# QUEENSTOWN AIRSPACE PETITION

Volume One, Version 2.0\*

29 May 2025

Queenstown – Milford  
User Group  
QMUG

Figure 3: Proposed modified T753 Ridge Peak SFC/4000ft

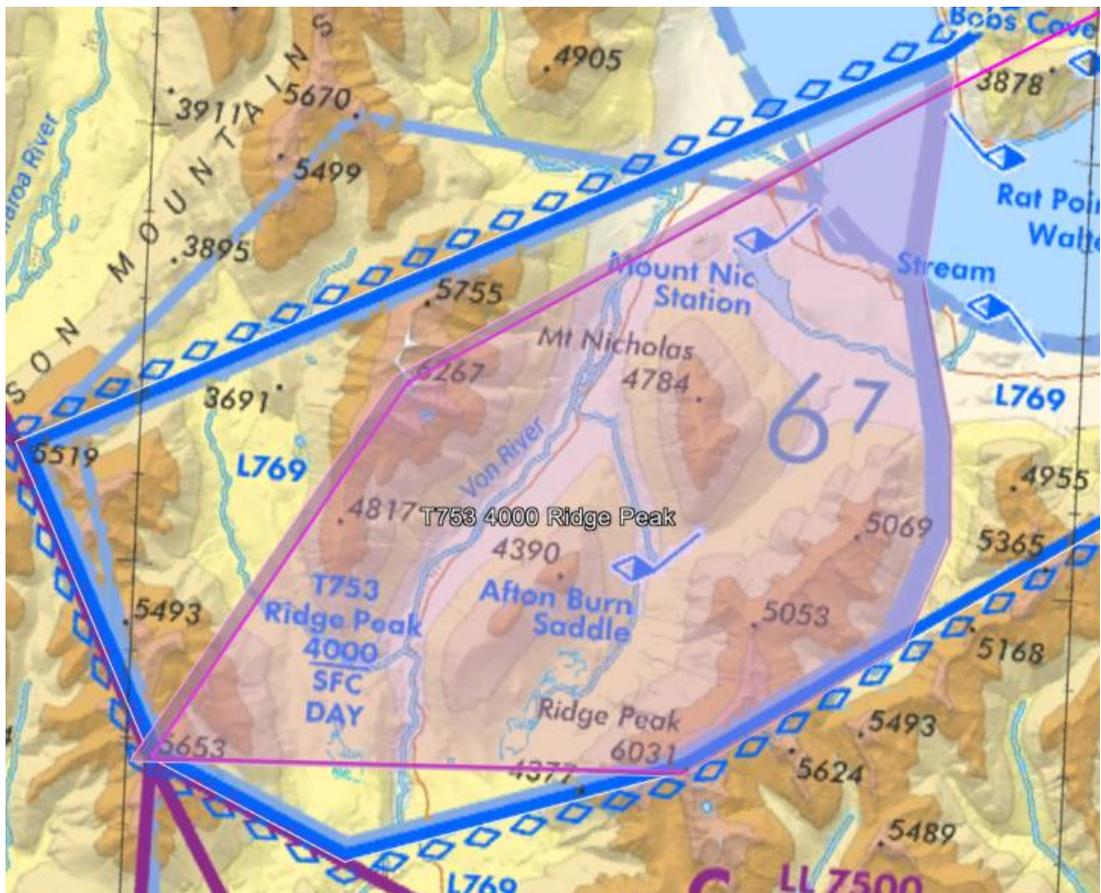
Reduced in size as a consequence of the QN CTR/C reduction. No additional separation evaluation is required as no additional transit lane airspace is required.

**Proposed T753 definition SFC/4000ft**

Figure 4: Proposed T751 Kingston SFC/5000ft

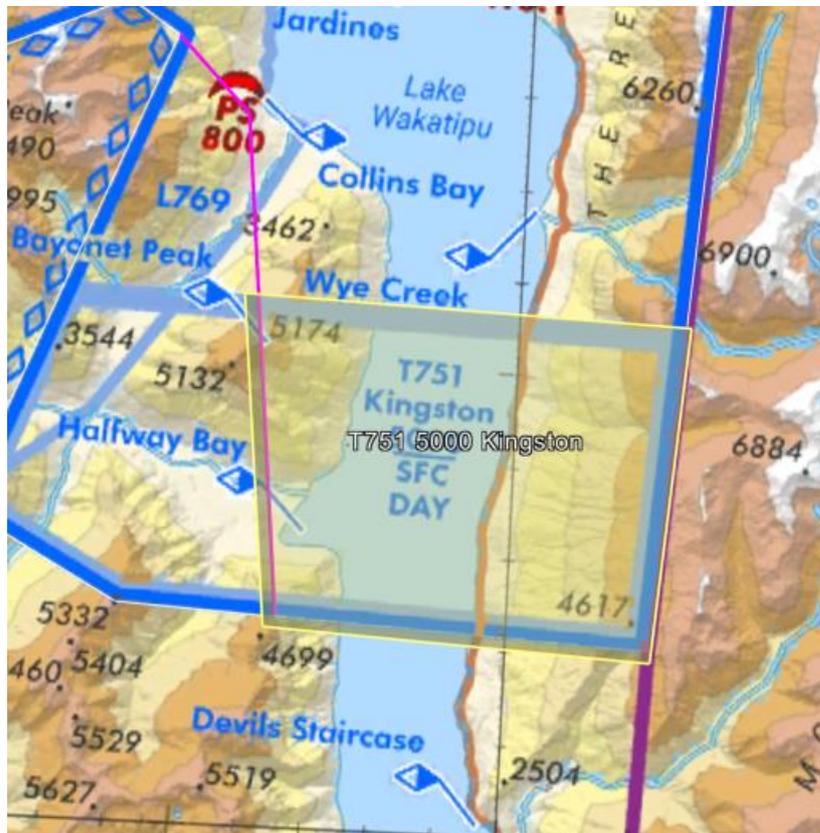
Reduced in size as a consequence of the QN CTR/C reduction. No additional separation evaluation is required as no additional transit lane airspace is required.

#### **Proposed T751 definition SFC/5000ft**

Figure 5: Proposed T750 Kawarau SFC/4500FT

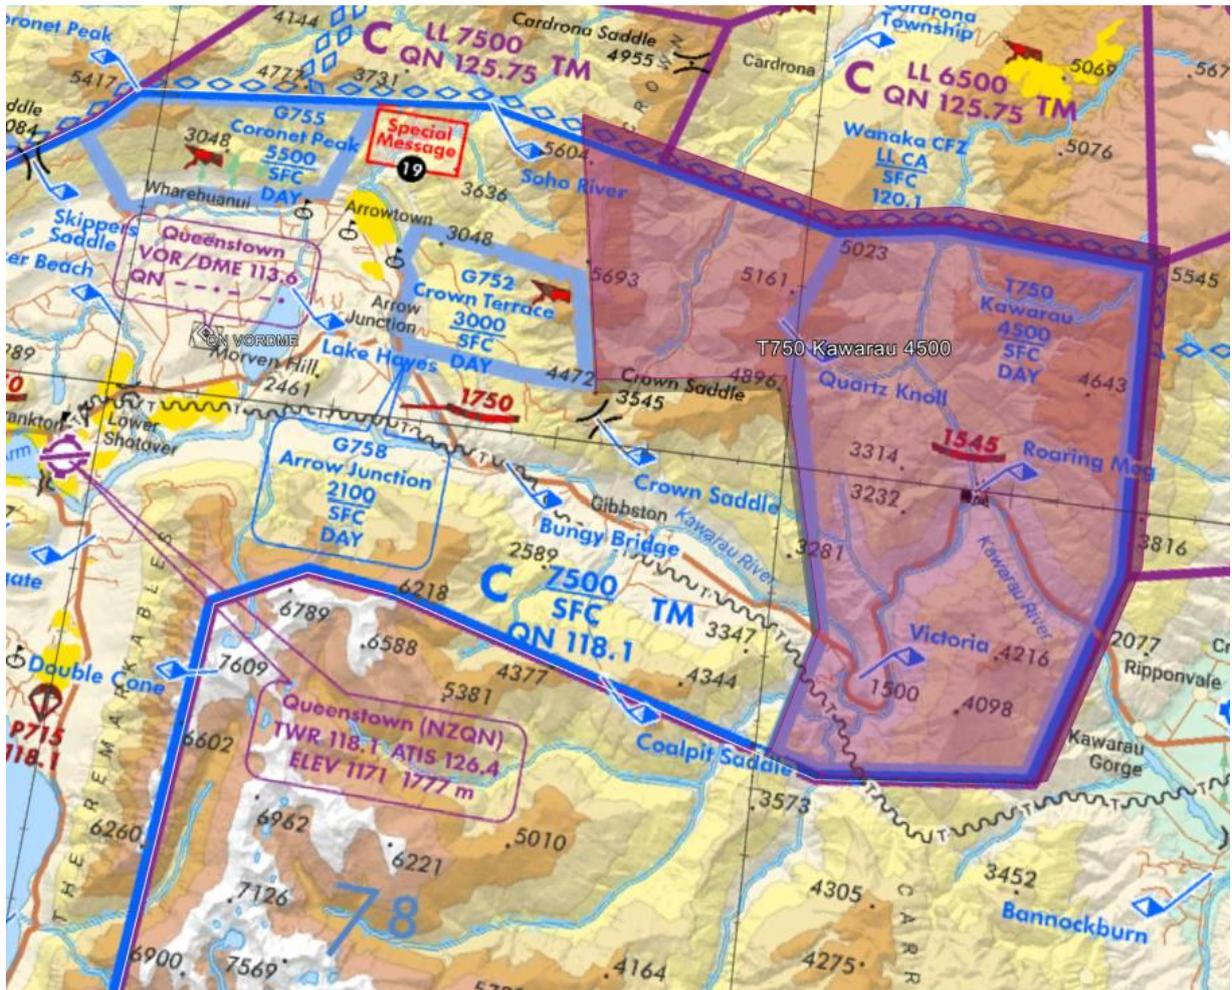
Increased lateral dimensions but remains SFC/4500ft.

### **Proposed T750 definition**

Figure 6: Proposed T2700W Walter Peak SFC/2700ft

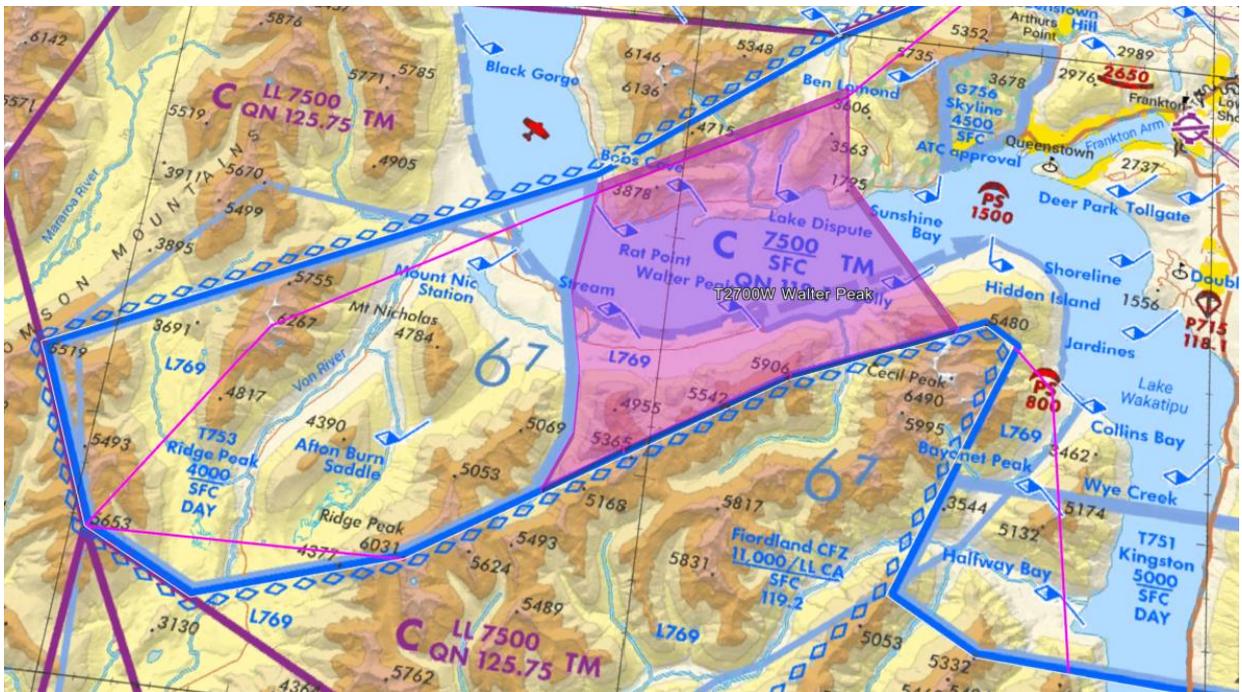
The controlling Instrument Flight Procedures for the proposed Walter Peak Transit Lane are the RNP Y and Z approach for RWY05, the RNP Y and Z RWY23 Missed Approaches, the RNP045 approach and the BOTNII SID.

Note: The Cat H RNP045 procedure would not be separated from T2700W.

#### Proposed Definition

Figure 7: RNP Y&Z RWY23 MA vs T (Walter Peak)

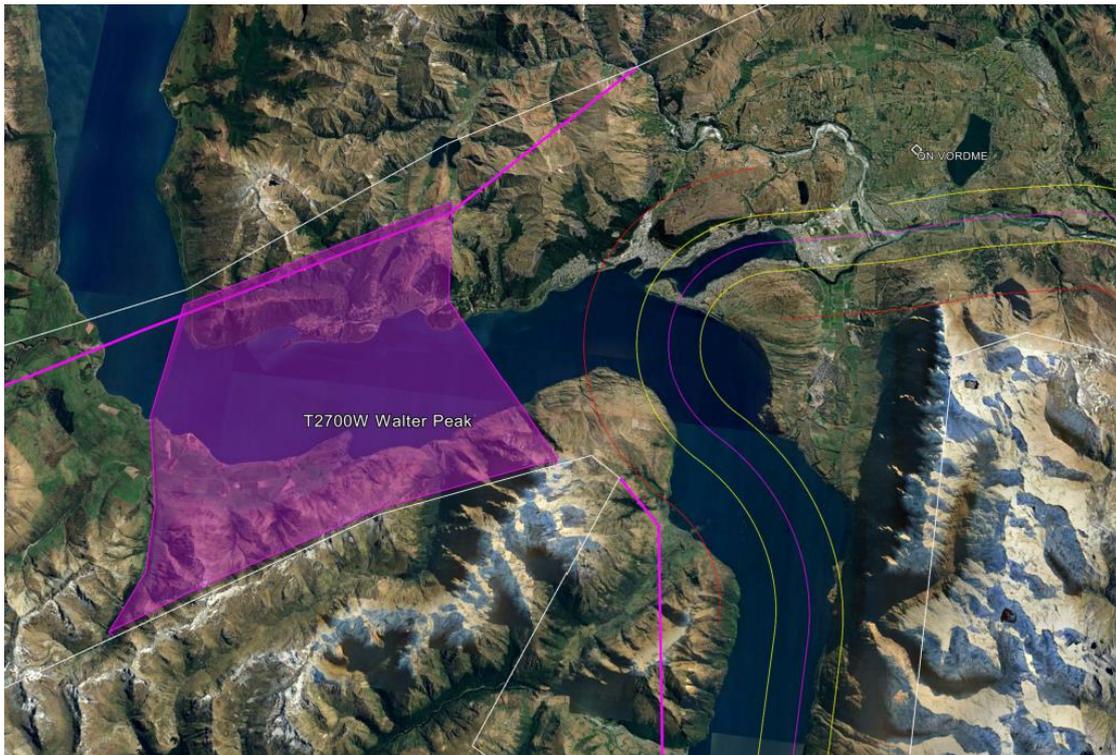
**RNP Y & Z RWY23 Missed Approach** - are laterally separated from the lateral protection areas of RNPx2 + 1 NM.

Figure 8: Buffer Area for RNP Y&Z RWY05 vs proposed T2700W

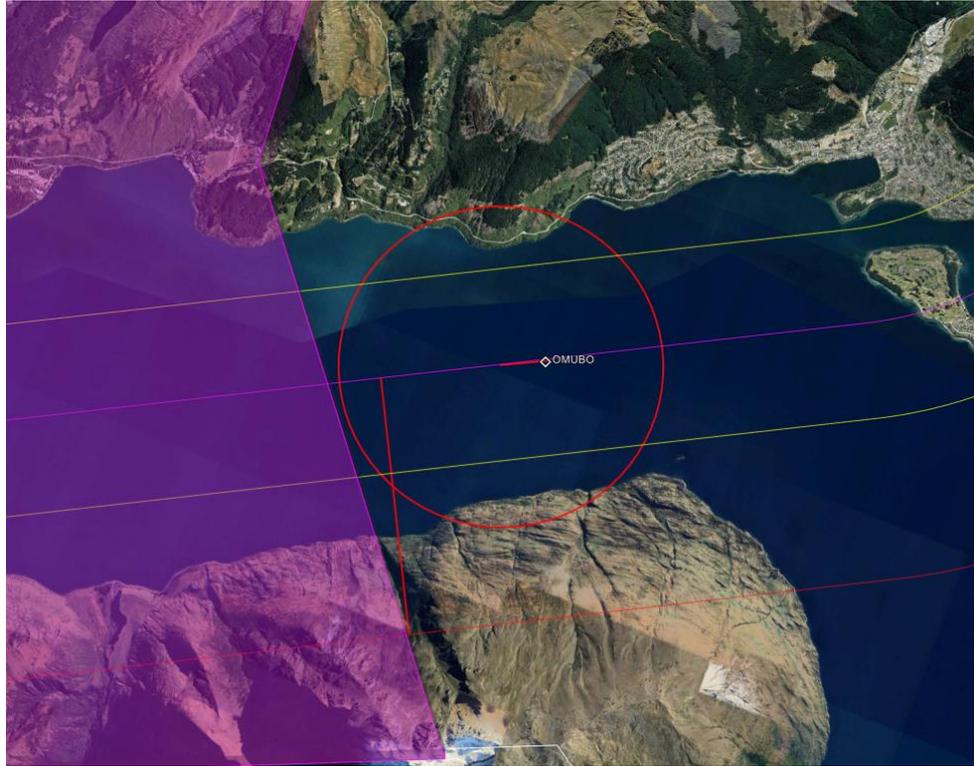
**RNP Y & Z RWY05** - OMUBO (FAF) is not below 3100ft, so 500ft above proposed transit lane upper limit of 2700ft will be 0.3NM prior to OBUBO at procedure 3.2° approach gradient.

The proposed controlling boundary of the Walter Peak transit lane is a direct line between two prominent geographical features, Gully and the 1795ft feature on the north lake shore.

On nominal flight path at the 500ft separation point above T2700W there is a 1.1NM buffer from the transit lane. This reduces to 0.75NM at the full width of the lateral protection area.

The co-submitters confirm that in their view, given the prominent geographical features that define this boundary, a slightly reduced buffer than 1NM at the limits of the lateral protection area would be acceptable.

Figure 9 BOTNII SID vs Proposed T2700W

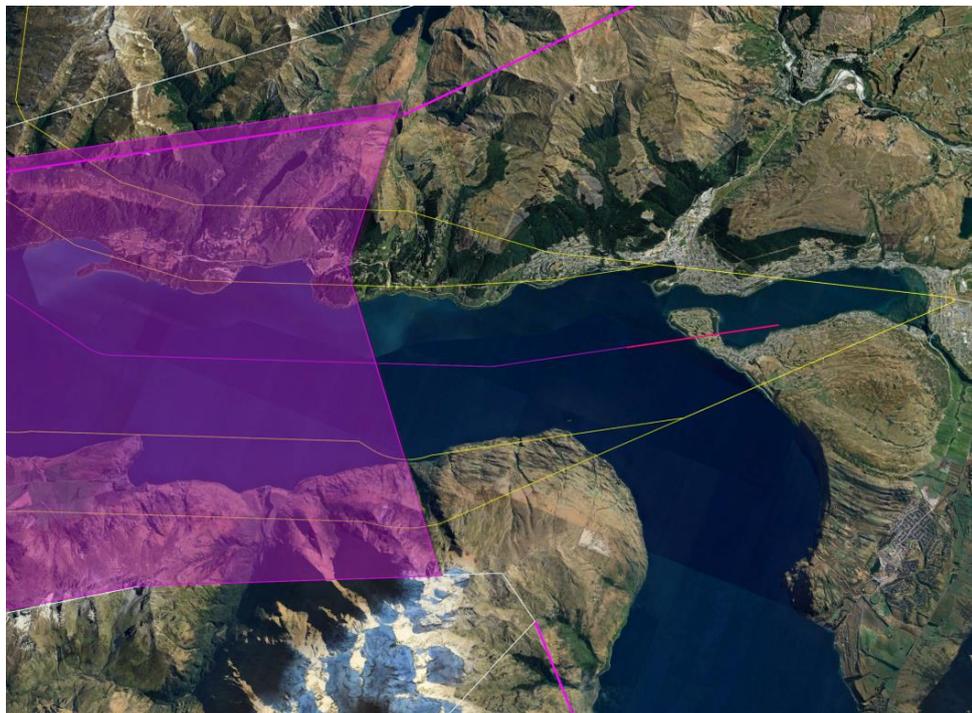
**BOTNII SID** - Crosses QN589 at or above 2250ft. 950ft of climb required to reach separation level above T2700W requiring 1.83NM. Vertical separation point is reached prior to a 1NM buffer.

Figure 12: RNP Z RWY05 vs proposed T3500S

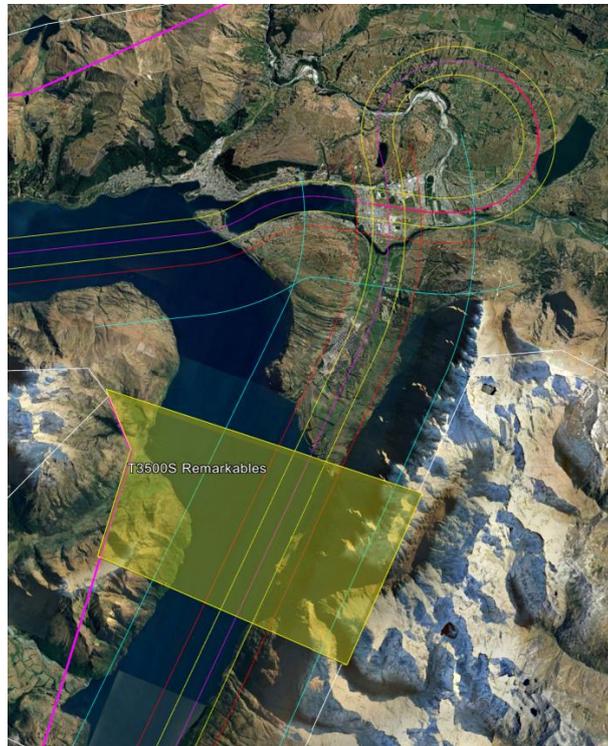
**RNP Z RWY05 Approach** - MDA 2324ft, 1676ft required to climb above proposed T3500S at default MA airspace containment gradient 5% (300ft/nm) requires 5.6NM.

Figure 13 Proposed T2700E Gibbston SFC/2700ft

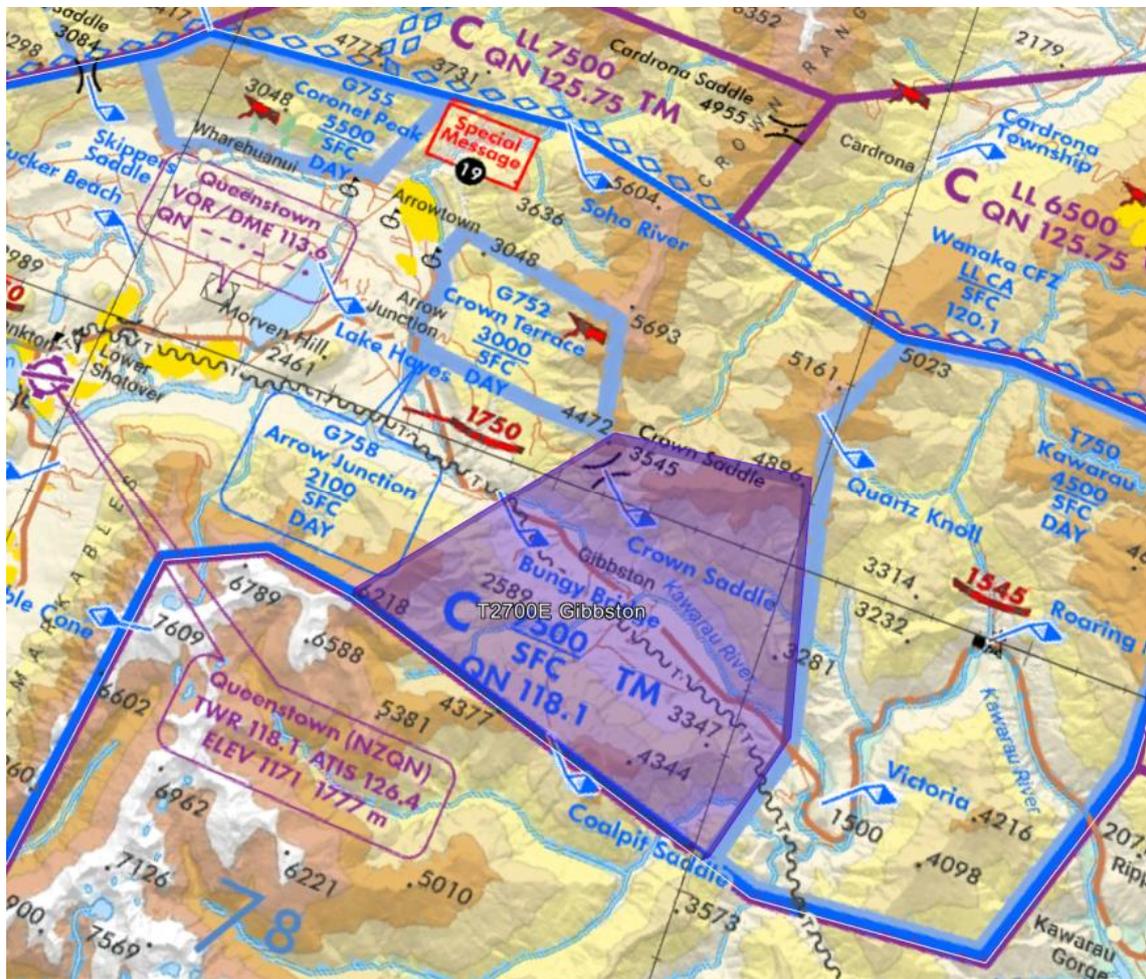
NZTXXX 1 445848.70S 1685944.60E (4896 feature) GRC

Figure 14: RNP Y & Z RWY23 vs proposed T2700E

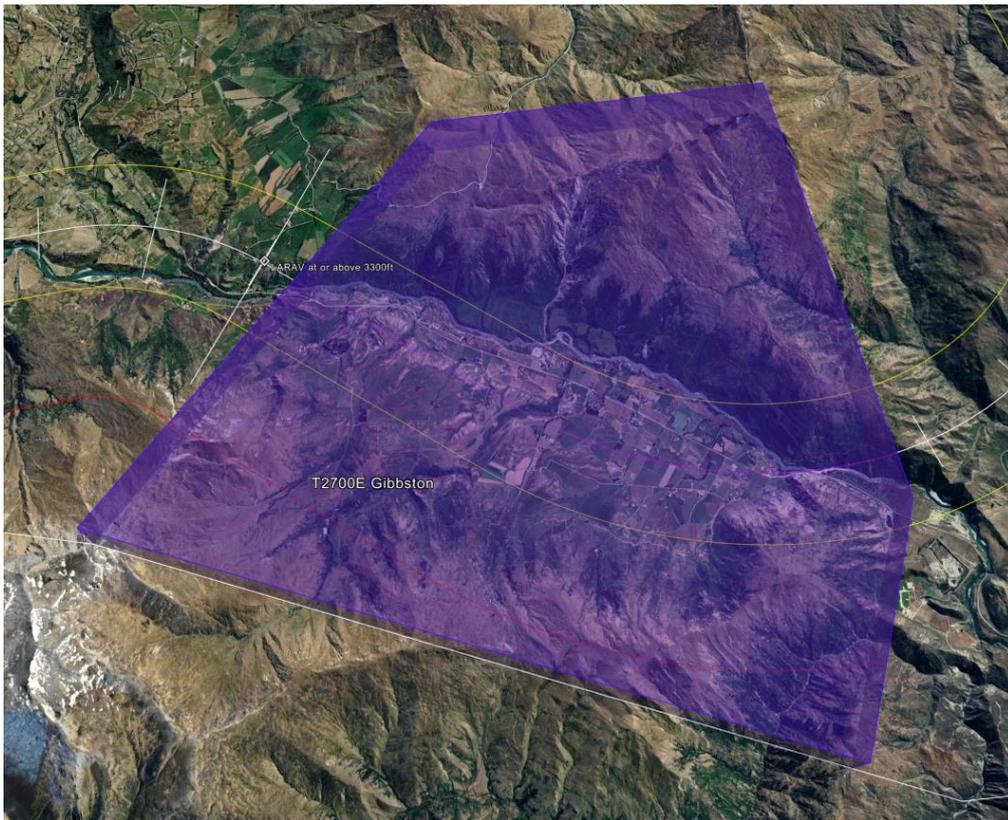
**RNP Y & Z RWY23** - At or above 3300ft at LARAV (FAF). Vertical separation point versus proposed T2700E is 0.3NM closer to QN at procedure approach angle of 3.2°.

At the boundary of the transit lane Gibbston Valley narrows significantly. Ben Cruachans, 6217 ft defines the boundary to the south, Bungy Bridge VRP in the centre of valley, and the 4472ft feature just Northwest of Crown Saddle to the north.

Such strong predominant geographical features will allow a reduction in the standard 1NM buffer from the vertical separation point. Buffer will be reduced to 0.5NM on the nominal track to 0.35NM at the limit of the lateral protection area.

The co-submitters confirm in their view that given such strong predominant geographical features that define this boundary, that a reduced buffer at the limits of the lateral protection area would be acceptable.

Figure 18: BIXAL2 SID vs proposed T2700E

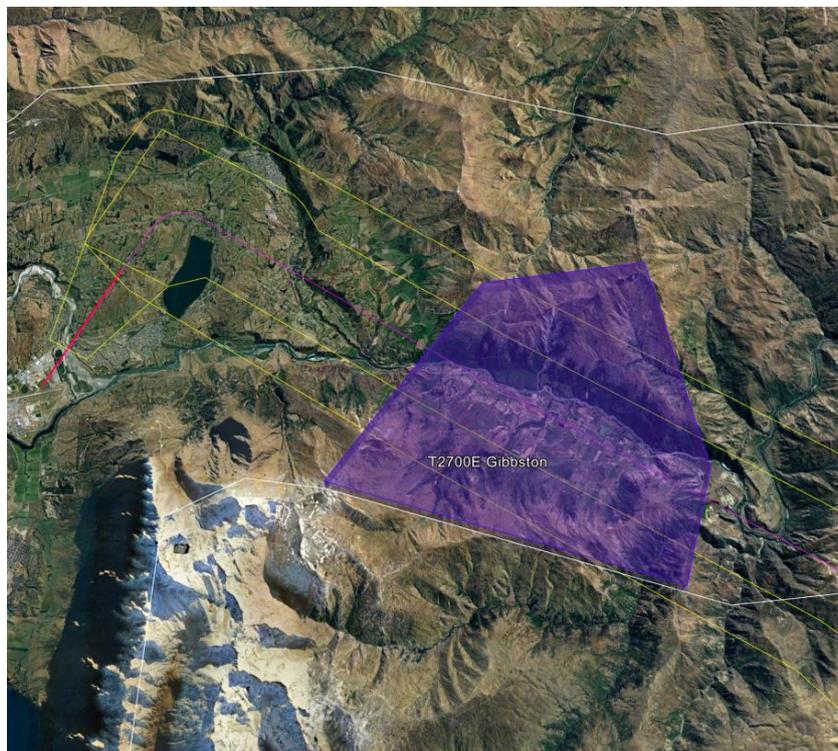
**SID BIXAL2** - Cross QN736 (IDF) at or above 1750ft, 1450ft to reach separation level above proposed T2700E at 570ft/NM requires 2.6NM. Vertical separation includes 1 NM buffer.

Figure 20 T753 & T2700W Frequency Assignment

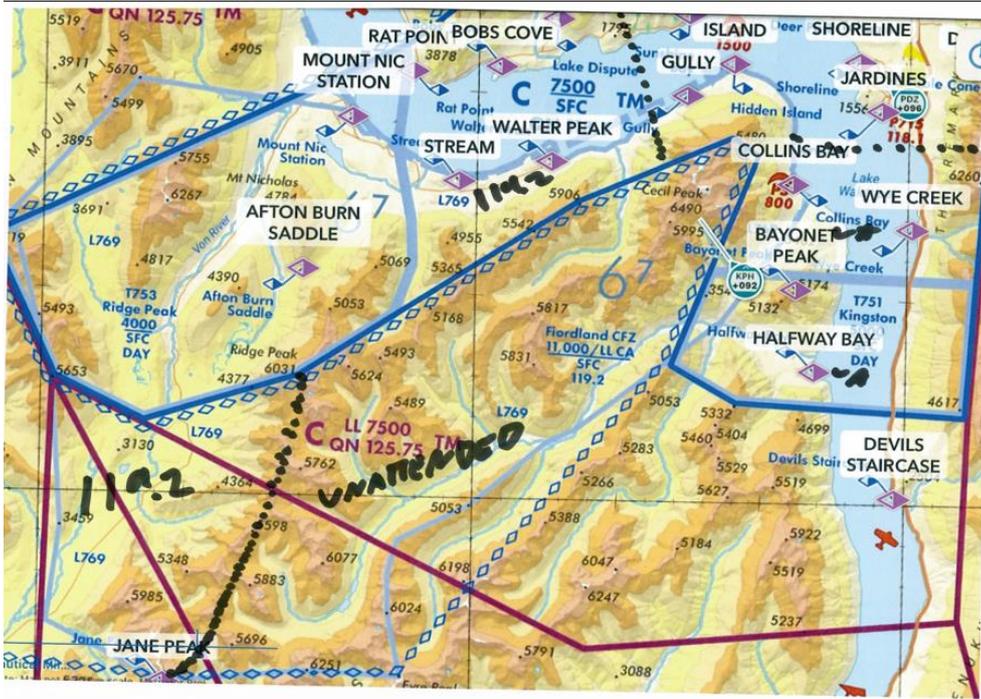
QMUG operators express a desire to have a specific frequency allocated to each Transit Lane to ensure that flight operations within each Transit Lane are communicating on the same frequency. Senior QMUG members met specifically to discuss frequency assignment considering all aircraft operations in the wider region.

Assign 119.2 MHz to T753 and the proposed T2700W Transit Lanes in addition to modifying the current CFZ boundary as indicated in the picture above. (New CFZ boundary line Ridge Peak to Jane Peak).
